Subject: Millennium Tower
301 Mission Street, San Francisco
Serious Situation Requiring Attention

On 7/10/19, almost three years ago, the undersigned, as requested, submitted a report to the Board opining on two proposed foundation plans: Partial external asymmetrical ("SGH") and full internal symmetrical ("LERA") engineered separately for retrofitting support to the differentially settled and tilted Millennium Tower. Our report (copy attached) and this supplement are provided as a public service. The full internal symmetrical plan was "vastly superior" to the partial external asymmetrical plan, however, unfortunately, the superior plan and its well planned implementation were not selected. The condominium owners elected to be paid cash in lieu of implementing the superior internal plan.

Subject: Millennium Tower
301 Mission Street, San Francisco
Two Differing Plans for Foundation Retrofitting

INTERNAL SYMMETRICAL FOUNDATION PLAN

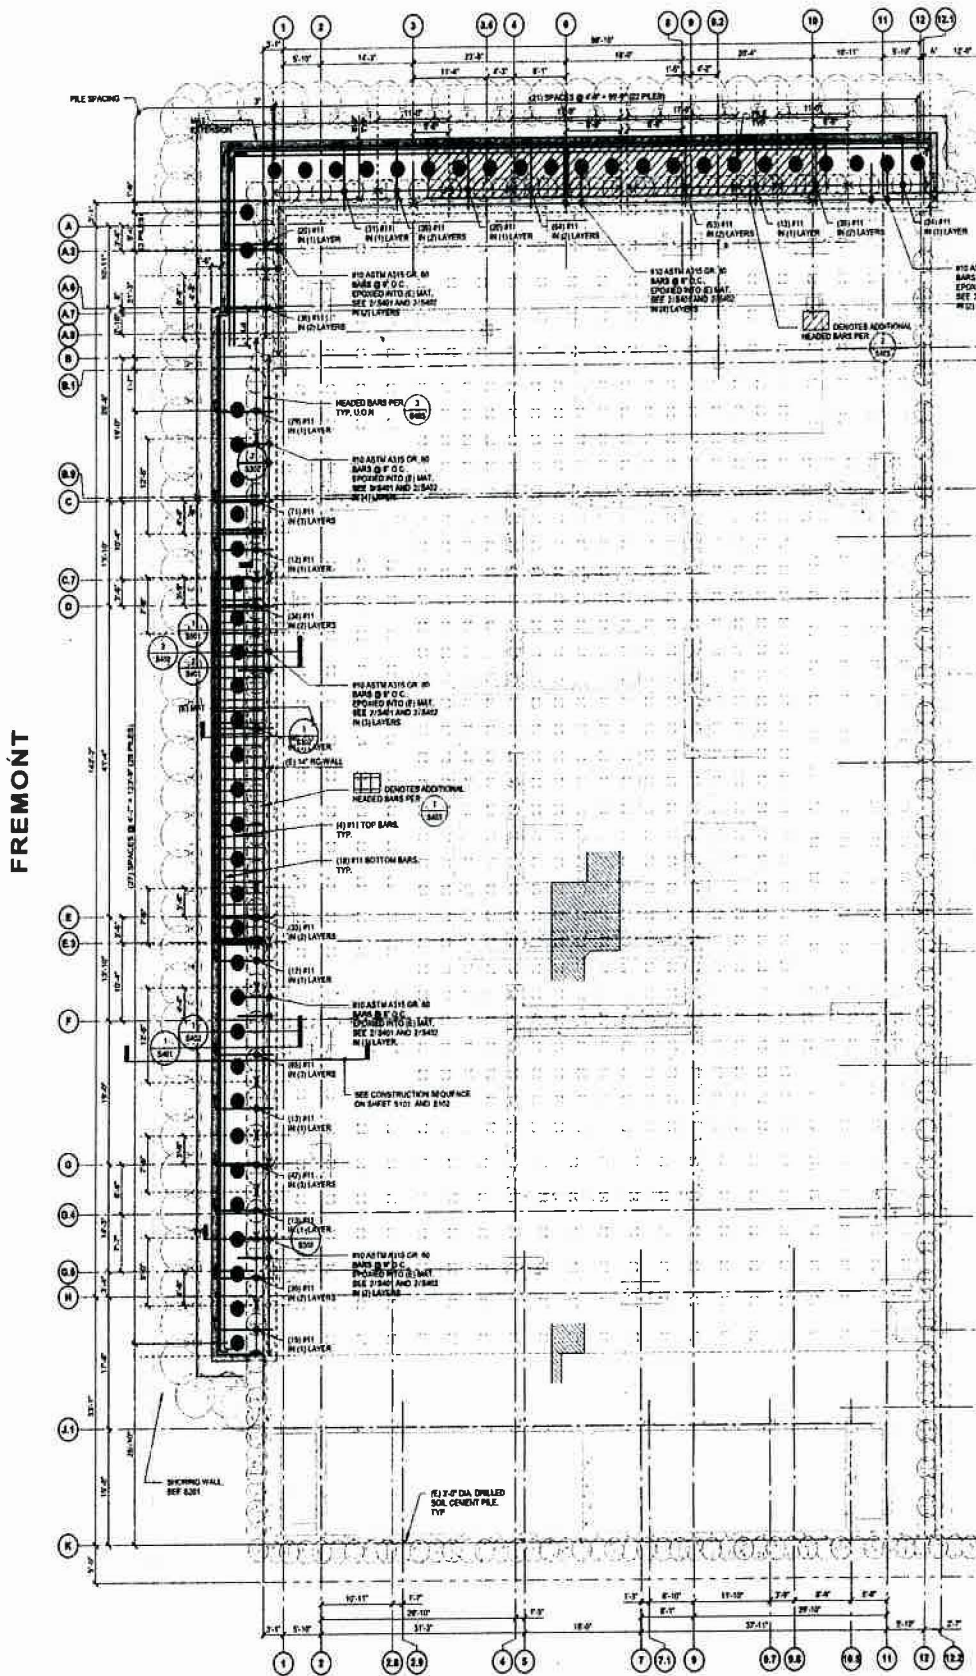
The internal plan (attached schematic), designed by Leslie E. Robertson Associates (LERA), Consulting Structural Engineers, designer of the World Trade Center in New York, has a total of 108 new steel jacketed piles, 54 on the Fremont side and 54 on the opposite side of the building, arranged in a symmetrical longitudinal and transverse pattern that are installed inside the basement and will perform entirely within the building's footprint. The upper portions of the 13-5/8 inch outside diameter 5/8 inch wall thickness steel rock piles are 30 feet long in and below the existing concrete mat, and inside the larger pipes are 9-5/8 inch outside diameter 1-3/8 inch wall thickness steel rock piles. The smaller piles extend through the larger piles into bedrock that is projected to be 220 feet from the bottom of the Millennium Tower mat portion of the substructure.

The entirely new pile system will provide full uniform and symmetrical vertical and lateral support for the Tower. The new lateral resistance to base shear provided by the 108 13-5/8 inch diameter piles below the mat is a much improved lateral force resisting system over the original design that relied on passive resistance against the basement wall and the prestressed concrete piles with the design assumption that the bottom of the mat substructure would remain level.

The new piles will be jacked into bedrock through holes cut through the basement slab. The jacking system uses the weight of the concrete building as a reaction. Pile locations as finally set were arranged to avoid MPE utilities, computer facilities, and fire pump house. Pile sections have threaded connections, there is no welding and annular space in the piles are grouted. The internal plan does not involve any dewatering and there is no drilling through soils. There is potential with the internal plan to at least partially return the substructure to a more level condition during the jacking process.

EXTERNAL ASYMMETRICAL FOUNDATION PLAN

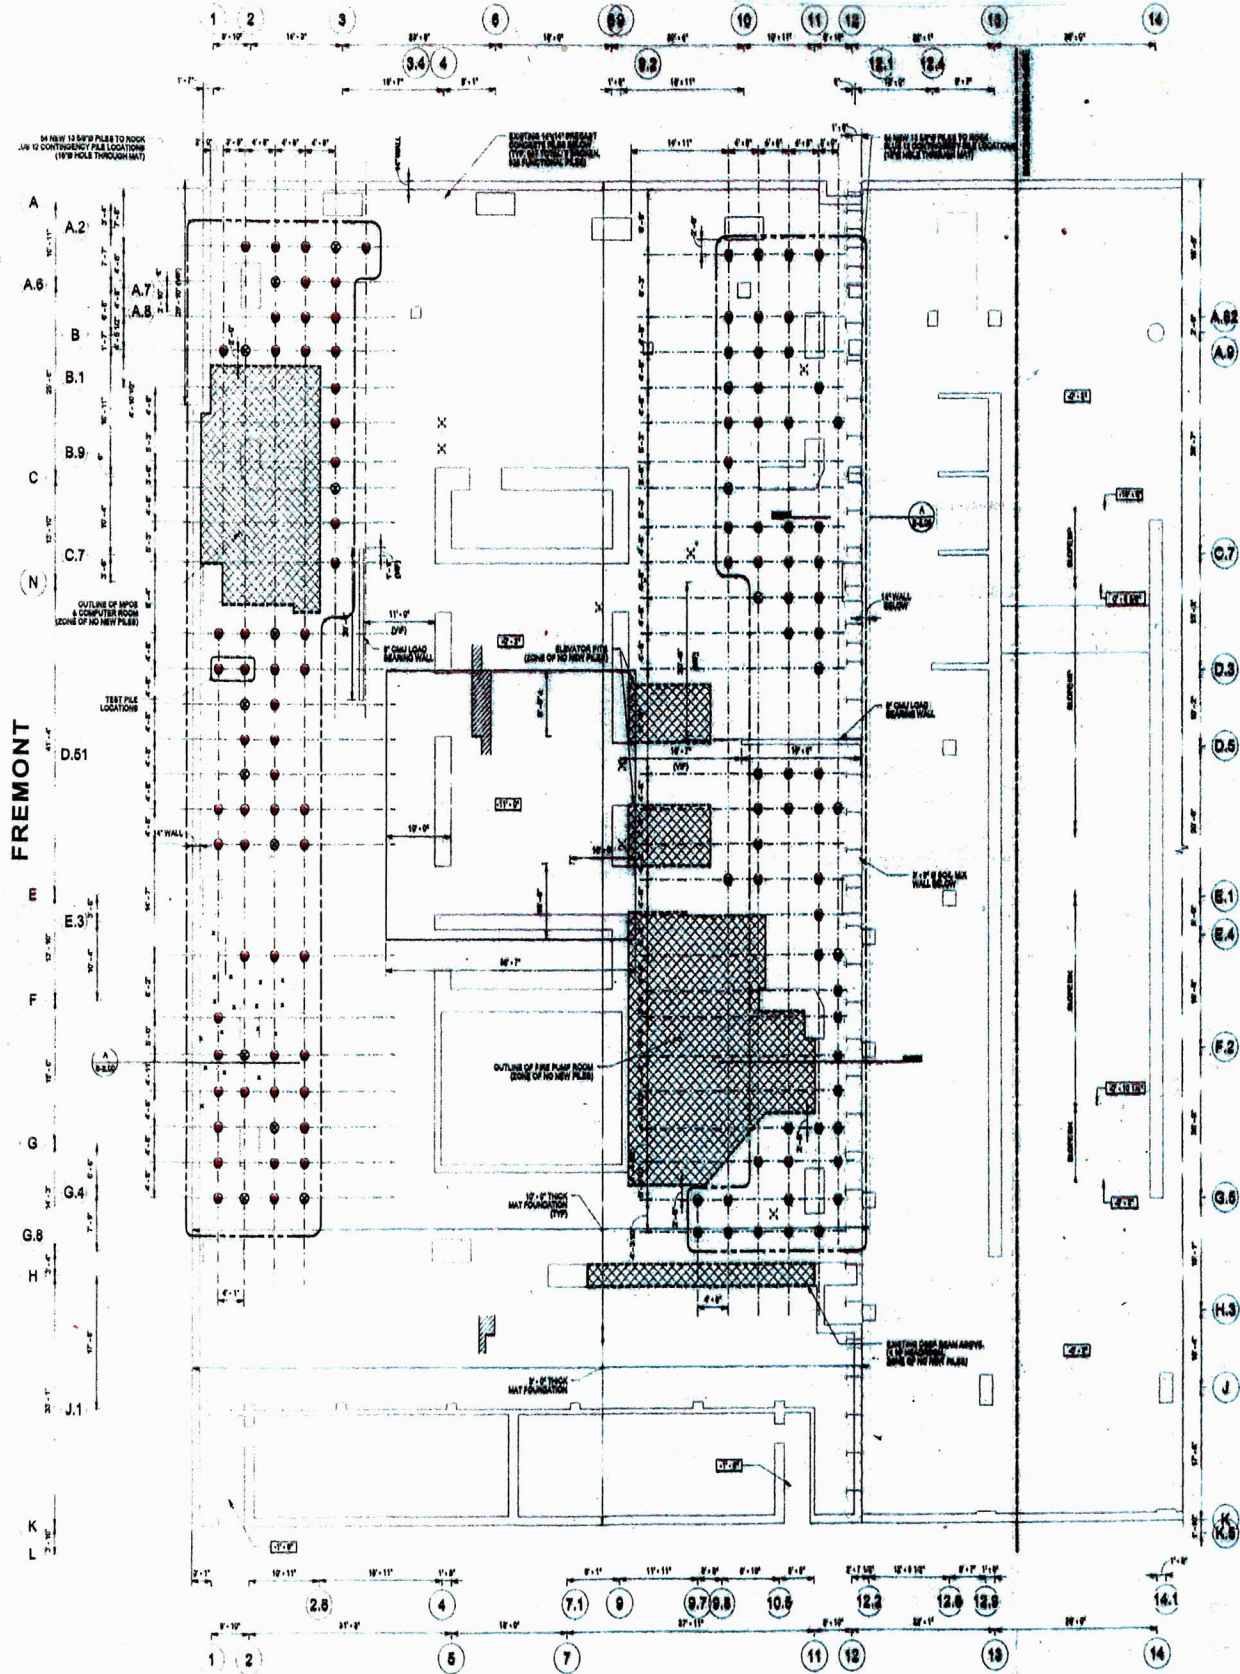
The external plan (attached schematic), designed by Simpson Gumpertz & Heger (SGH) Consulting Engineers has a total of 52 drilled and cased very closely spaced piles along Mission and Fremont Streets; 30 along Fremont and 22 along Mission that are connected by a continuous concrete pile cap that will be doweled into the existing substructure so the new piles will provide bedrock support, which will be eccentric, for about one-fifth of the building's total load.

An SPTC wall 47 feet deep will be built to shore a 27 foot deep, 10 foot wide excavations in both streets between the shoring and the existing substructure. A 5 foot thick grout plug will be constructed at the bottom of the excavation to prop the shoring at excavation subgrade, restrict backslope subsidence and basal heave, and provide an area to work in the dry. Piles will be drilled from the street and cased from bedrock to the level of the mat's bottom.

The major initial problem with construction of the external plan that has no realistic practical or theoretical solution is further loss of groundwater, which is likely to cause more irreparable damage to the building's substructure regardless of subsequent attempts to counter the effect of supporting the existing mat with flat jacks on the piles. Drilling, casing, and removal of spoils from the site to construct closely spaced 52 piles, 36 inch diameter holes to the top of the Old Bay Mud (80 feet below street grade) to become 24 inch diameter piles more than 200 feet deep will cause loss of ground which comes with loss of groundwater that will worsen the problem from dewatering that created the condition in the first place in the area of the planned new piles.

Exacerbating the loss of groundwater with removal from Fremont and Mission Streets of about 1,500 CY of soil and water from the combined locations of the piles will be dewatering necessary to excavate the planned 10 foot wide 27 foot deep trench, 125 feet along Mission Street and 175 feet along Fremont Street, about 3,000 CY. Present groundwater levels near the intersection of Fremont and Mission Streets are at about 23 feet from street grade. With construction of the grout plug in Young Bay Mud, the trench will require groundwater levels along Fremont and Mission Streets to be drawn down to at least 33 feet from street grade, or about 10 feet down from the present GWT.

Groundwater withdrawal without recharge lowers the groundwater table which with building loads increases overburden pressure on compressible soils. Lowering the GWT another 10 feet for the design and to create workable space in the Young Bay Mud for the grout plug will cause the building to further settle differentially with associated damages to the building's substructure. From geometry, for every new inch of differential settlement of the Millennium Tower at Fremont and Mission Streets, the top of Millennium Tower will lean about an additional 4 inches. The tilt will be unacceptable to the owners of the residences and the public. Severe increased breaking and cracking of the concrete base and rotation/failure of the pile heads due to more differential settlement will cause further irreparable damage.

The asymmetrical external foundation plan, consisting of perimeter piles along two adjacent sides of the building, will create a major horizontal structural irregularity. This will be a torsional irregularity as the new piles are relatively strong load-resisting elements but there are no comparables on the opposite sides of the building. Earthquakes have repeatedly shown that buildings that have irregular configurations suffer greater damage; for irregular plans, torsion is caused by eccentricity between the centers of mass and rigidity. In regular structures inelastic response with energy dissipation and damage produced by strong ground shaking will be distributed throughout the building. For the external foundation plan, where a seismic event will generate base shears that are derivatives of the building's weight in precisely the direction of the new pile rows which may passively resist them, forces in other directions will cause torsion to other building elements or will not be resisted by available passive, such as along Minna Street. In such irregular structures, inelastic behavior may be concentrated. The existing 14 inch square (with chamfered corners) piles, even with tops reinforced likely have rotated heads, crushed portions of concrete, and bent bars as a result of the differential settlement of the mat foundation that was meant to tie the piles together for group action. Narrow concrete piles that are prefabricated with prestressing strands are for the purpose of resisting breakage during lifting, and with cushions to resist driving forces; their heads are not meant to rotate. Ground motions acting on a skew with respect to the building's axis can cause torsion. 2016 California Existing Building Code §403.9.4, for voluntary seismic improvements, requires that alterations do not create a structural irregularity.
